APPLICATION NO.	FILING DATE	FIRST NAMED INVENTOR	ATTORNEY DOCKET NO.	CONFIRMATION NO.
10/797,839	03/10/2004	John R. Blake	247171-000390USPT	5664
41230 7590 09/12/2008 CUMMINS-ALLISON CORP. C/O NIXON PEABODY LLP 161 N. CLARK ST., 48TH FLOOR CHICAGO, IL 60601				
EXAMINER				
MCCLAIN, GERALD				
ART UNIT		PAPER NUMBER		
3653				
MAIL DATE		DELIVERY MODE		
09/12/2008		PAPER

Office Action Summary

DETAILED ACTION

FIG. 4

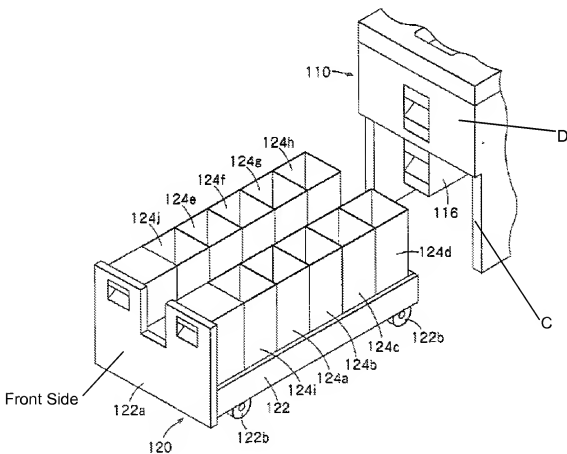
(FIG. 2); second position (FIG. 4); manifold (location of 152); coin paths (152);
dampening mechanism (See FIG. 4 below, C & 122a and 122b);

Claim 4: dampening mechanism (See FIG. 4 below, C and 122a); coin receptacle station (120); first end (See FIG. 4 below, C); housing (110); second end (See FIG. 4 below, Back Side (opposite Front Side) of 122a).

Claim 15: rear side (See FIG. 4 below, D); housing (See FIG. 2, 110);

Claim 16: front side (See FIG. 4 below, D; Note: the location of D can be defined as the rear or front side); housing (See FIG. 2, 110);

Regarding (2), there is no specific structure of the dampening mechanism claimed except a first and second end as identified in FIG. 4 above.

FIG. G1

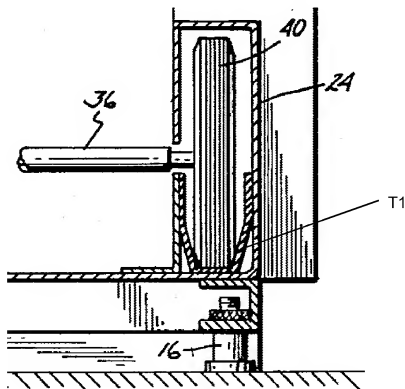
Muellner shows a similar device having a track (see FIG. G1 below, T1) for the purpose of receiving and capturing the casters (column 2, lines 57-66). Therefore, it would have been obvious to a person having ordinary skill in the art at the time the invention to modify Hino as taught by Muellner and include Muellner's similar device having a track for the purpose of receiving and capturing the casters.

Muellner shows a similar device having a track (see FIG. G1 below, T1) for the purpose of receiving and capturing the casters (column 2, lines 57-66). Therefore, it would have been obvious to a person having ordinary skill in the art at the time the invention to modify Hino as taught by Muellner and include Muellner's similar device having a track for the purpose of receiving and capturing the casters.

Regarding the track T1 above, note that it is applied directly under the wheels of Hino. Therefore, 122 is directly over the track and wheels (See FIG. 3 of Hino, 122).
